NMED/GWB-93/1

**INITIAL ASSESSMENT OF
THE GROUND WATER MONITORING PROGRAM
AT LOS ALAMOS NATIONAL LABORATORY,
NEW MEXICO**

NEW MEXICO ENVIRONMENT DEPARTMENT

January 1993

Figure 5. LANL's conceptual hydrogeologic model (Aldrich, 1992).

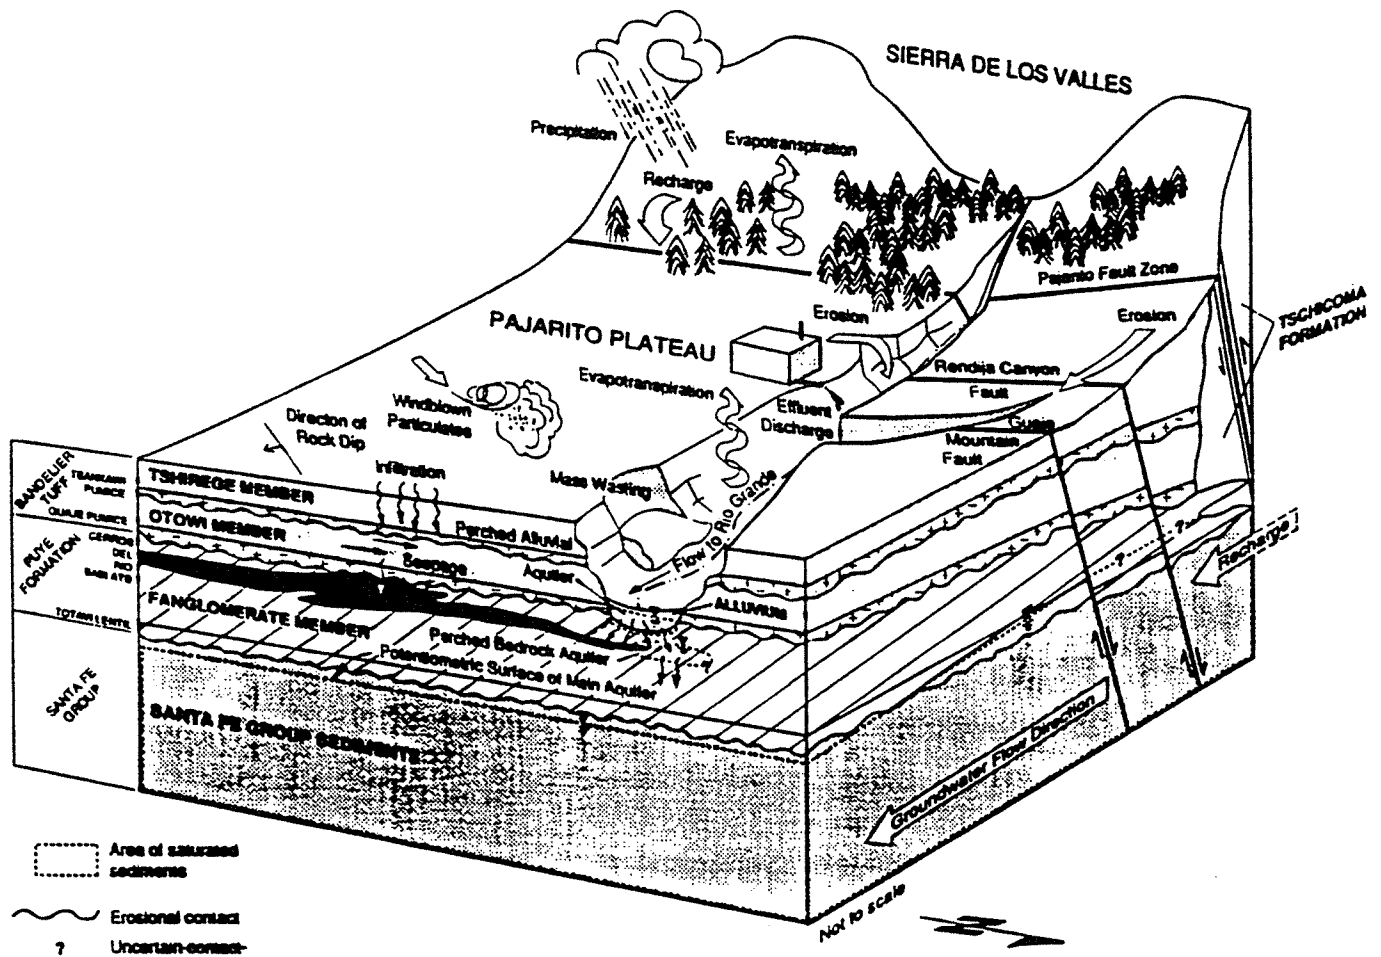
Again, as this is the initial assessment, the focus is on very basic questions. The adequacy of the monitoring network at LANL depends to a very large extent on the accuracy of the conceptual hydrogeologic model upon which it is based. In his evaluation of environmental monitoring at LANL, Kelly (1975) concluded that further hydrogeologic data were needed to design an effective monitoring system. Although some progress has been made in this area, there are still concerns about LANL's conceptual model, the hydrogeologic data base, and the presentation of surveillance information.

1. The recharge area(s) for the main aquifer under the Pajarito Plateau has not been clearly identified. Most RCRA operating permits, closure plans, and annual surveillance reports

state that "major recharge to the main aquifer is from the intermontane basin of the Valles Caldera in the Jemez Mountains west of Los Alamos", following Purtymun (1974). The water-level map published by the Lab does suggest a recharge area to the west. The Pajarito fault zone at the west edge of the plateau could provide a pathway for some of this recharge. However, stable-isotope data suggest that some component of recharge occurs at elevations higher than available in the Jemez Mountains (Goff and Sayer, 1980). The Sangre de Cristo Mountains have been suggested as the site of these higher elevations. Further work is needed on this matter.

2. Maps published by the Lab show that the main aquifer is generally unconfined, except in a wedge-shaped area near the central part of Los Alamos County. Since unconfined conditions suggest connection with the surface (i.e. atmospheric conditions occur at the water table), the common contention in operating permits and work plans, that the Bandelier Tuff is an impermeable barrier to recharge, does not seem to be valid over most of the plateau. Further work is needed to resolve this issue.

Figure 6. Pre-development water-level map of LANL (Purtymun and Stoker, 1988).

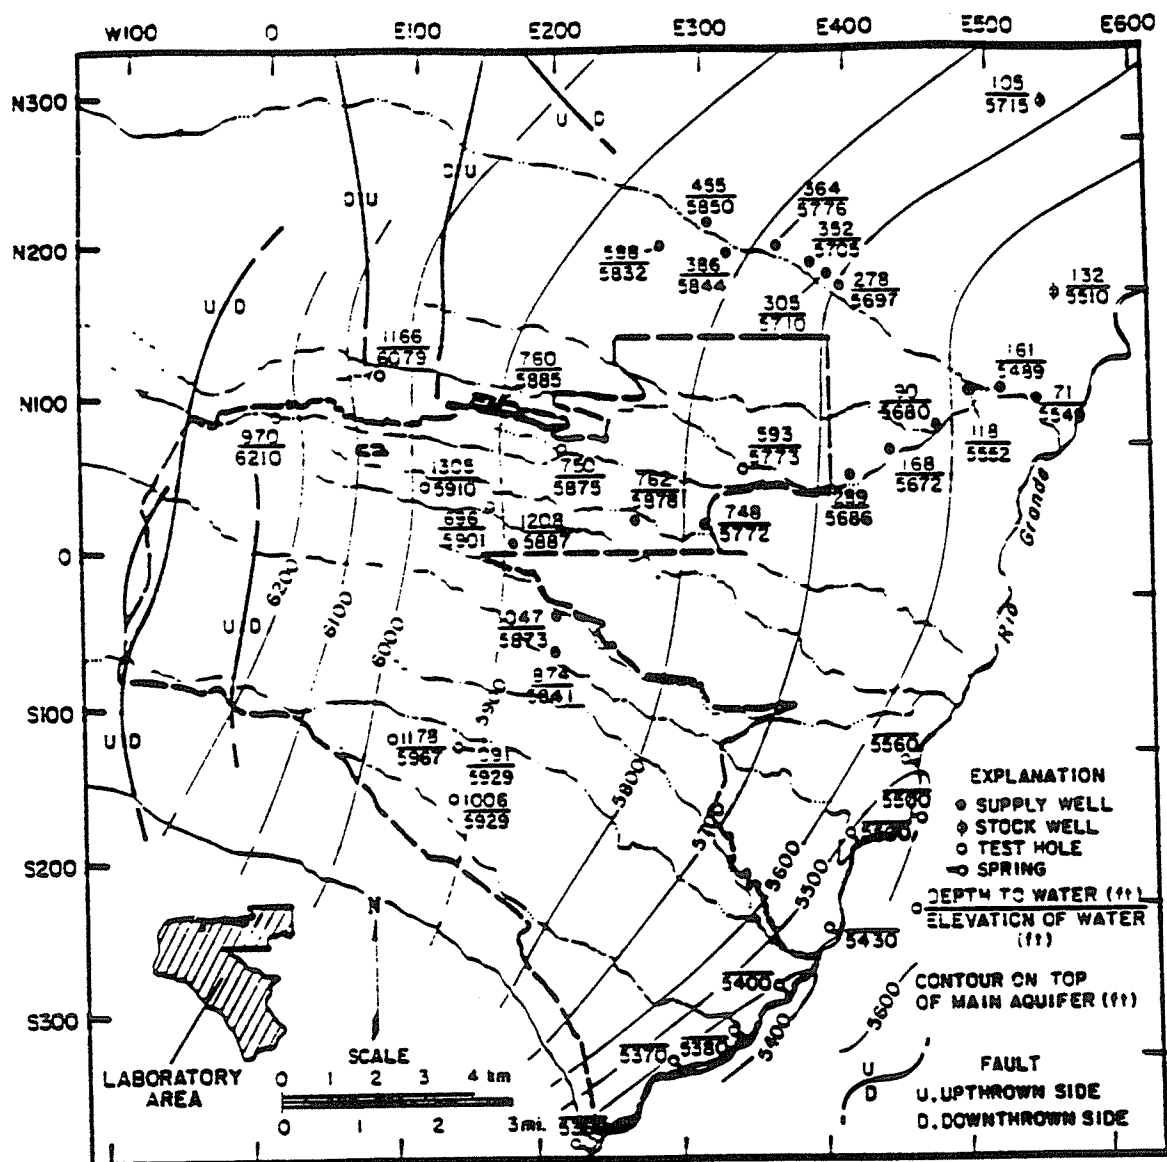
15. Previously published water-level maps essentially depict pre-development conditions: no impacts of pumping at production wells (i.e. cones of depression) are indicated (Figure 6). Yet, water-level changes (i.e. drawdown values) are regularly given in the annual reports on the water supply at LANL. Modeling by McAda and Wasiolek (1988) predicts significant cones of depression in the future as well. As ground-water flow is toward such depressions, their position and extent are critical to both designing and evaluating the monitoring network. Water-level maps for the Lab should include these features.

Figure 7. Water sampling sites at LANL (Environmental Protection Group, 1992).

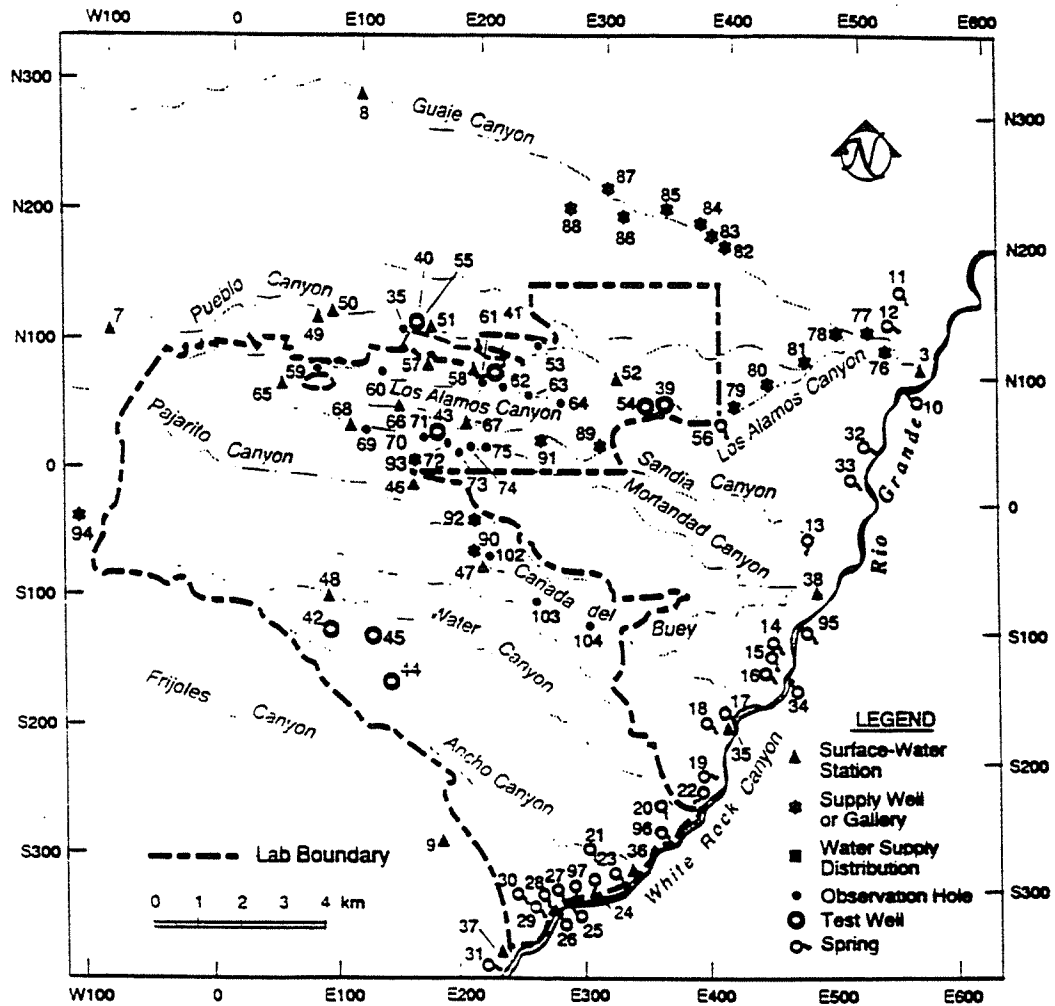
6. As noted above, the map of monitoring wells/sites in the surveillance reports should also show the major disposal areas (not every SWMU) that are being monitored, and contours that represent recent water-level information.
